CIMARRON CORPORATION

**ANNUAL SUBMITTAL OF
27(e) CHANGES FOR (2005)**

**DOCKET NO. 070-00925
LICENSE NO. SNM-928**

Re: Docket No. 070-00925; License No. SNM-928
Annual Submittal of 27(e) Changes

Figure 3-1

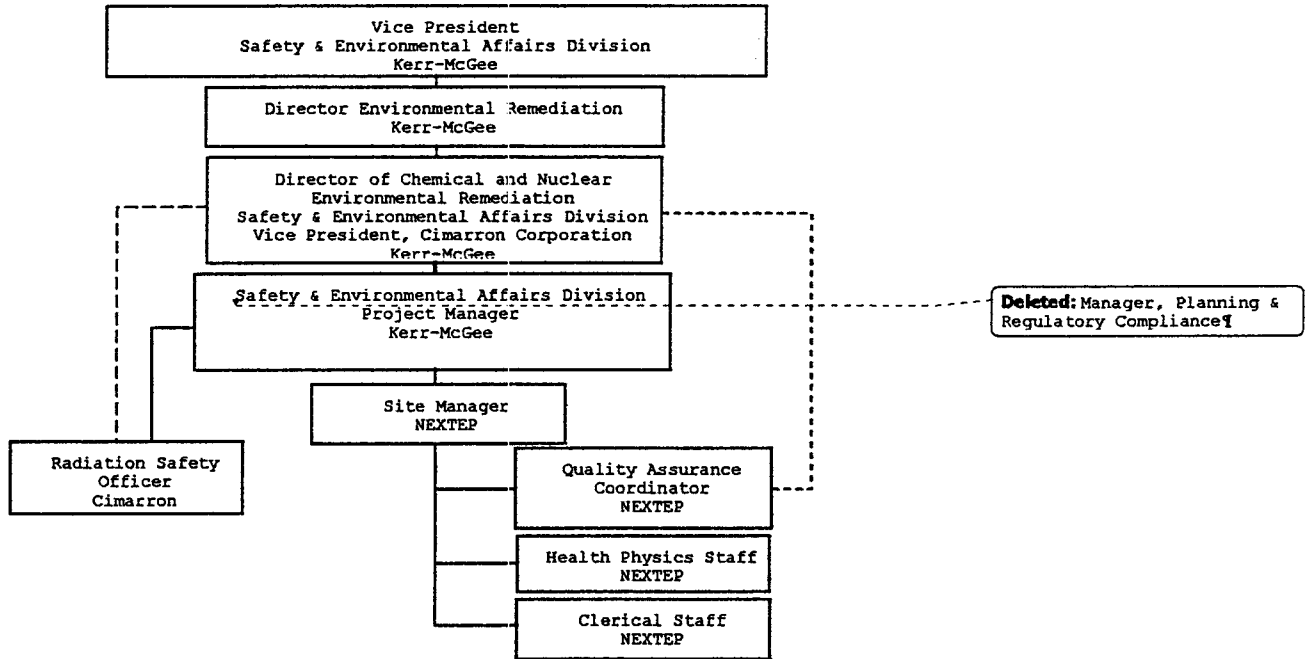
Revision to Section 3, Figure 3-1 (Organizational Chart) of the Radiation Protection Plan.
--

- Revisions to Radiation Protection Plan (Annex A) Sections 6 thru 10:
 - Section 3 – Figure 3-1 Organizational Chart – Changed job title, Manager, Planning & Regulatory Compliance Safety & Environmental Affairs Division Project Manager to read – Safety & Environmental Affairs Division Project Manager, Kerr McGee

Figure 3-1

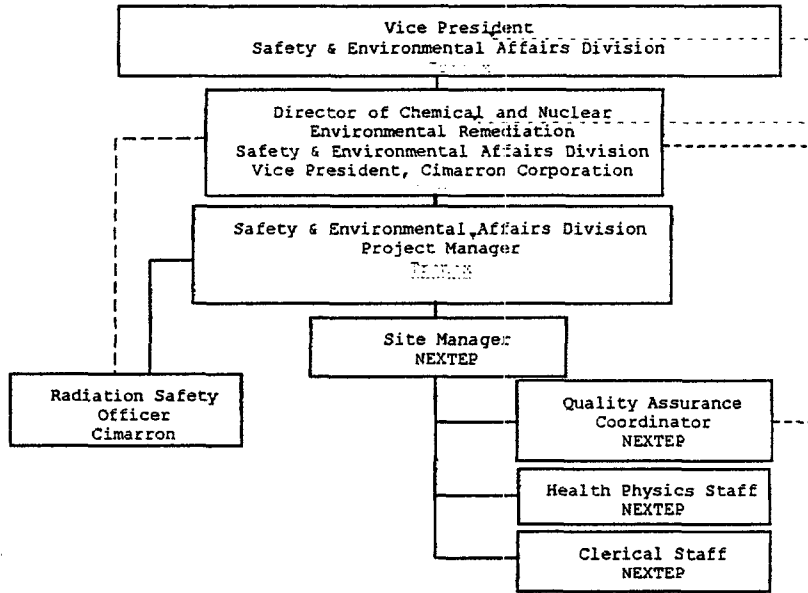
- Revisions to Radiation Protection Plan (Annex A) Sections 1 thru 5:
 - Section 1 – Reviewed no changes
 - Section 2 – Moved responsibilities for individuals to Section 3, Removed ALARA committee responsibilities which are outlined in section 4.3
 - Section 3 – 3.2 Added responsibilities from Section 2, 3.5 revised verbiage to clarify control of Radiation Procedures – Figure 3-1 Revised Organizational Chart to reflect Tronox personnel
 - Section 4 – 4.3 added discussion of new activities plans to ensure that ALARA considerations are met
 - Section 5 – 5.3 revised to state that surveillances are conducted under the guidance or direction of the Quality Assurance Coordinator
